FEDERAL-AMERICAN PARTNERS

Re: Subgrade Tailings Disposal
Plan, TFN 1 3/142

SUBJECT: Millwaste Alternatives

DEQ PROPOSAL #2

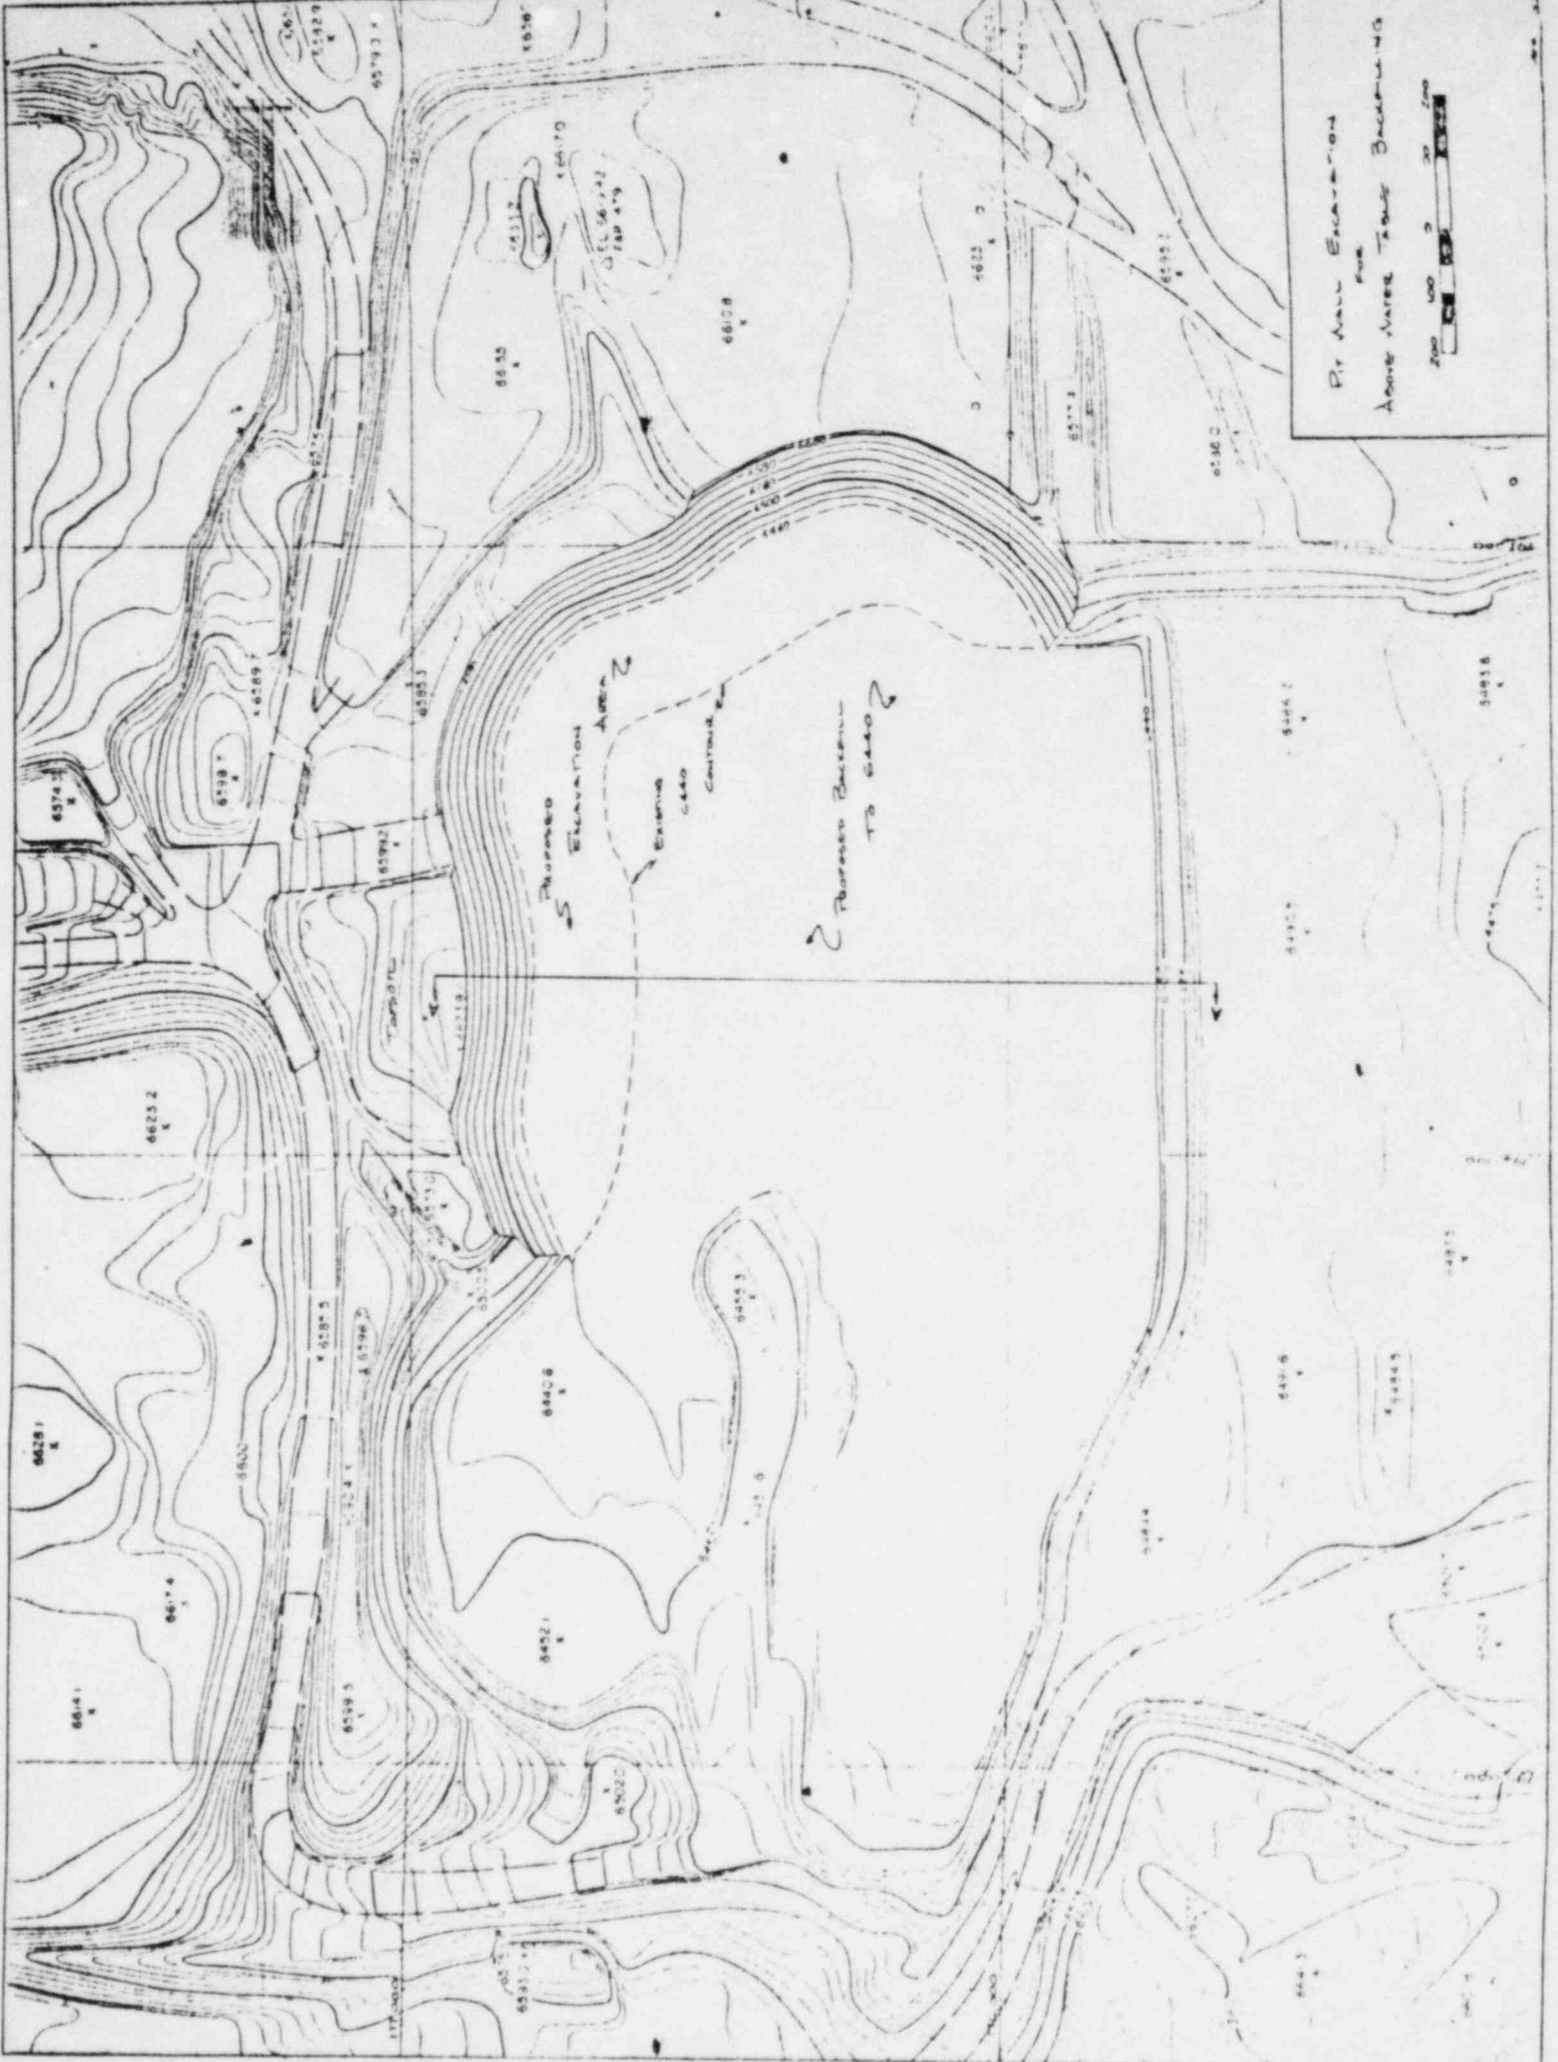
You also suggested in your letter that if the material used to backfill the pit above the water table were borrowed from the pit wall, thereby increasing the size (and volume) of the pit, less storage capacity would be lost. This suggestion was studied by Federal-American Partners' Engineering Department and their analysis is presented in the enclosed memorandum from Gary Gavin to Bob Taylor. What you suggest is true but at some additional cost to the project as the memorandum indicates. The savings in storage capacity would still leave a shortfall in required storage volume of about thirty percent.

A brief study was made to determine the economic and volumetric feasibility of the DEQ proposed alternative to above water table backfilling of the Sagebrush Millwaste area. The proposed alternative is as per DEQ letter of November 24, 1982 to Niles Andrus. The basic difference in this proposal is that backfill material would be "borrowed" from the pit wall. Thus, this alternative would increase the size, and volume, of the pit and less storage capacity would be lost.

A typical cross-section and proposed contour of the pit wall borrow area is enclosed. A brief rundown of economics, and storage volumes:

Estimations made on the proposed alternative indicate that storage volume could be increased by roughly 300 acre feet. The total volume available would then be increased to 3,479,293 tons. As in the previous September 9th study, this is assuming a 6490 top elevation. This alternative would not meet the required storage volume by about 30%**.
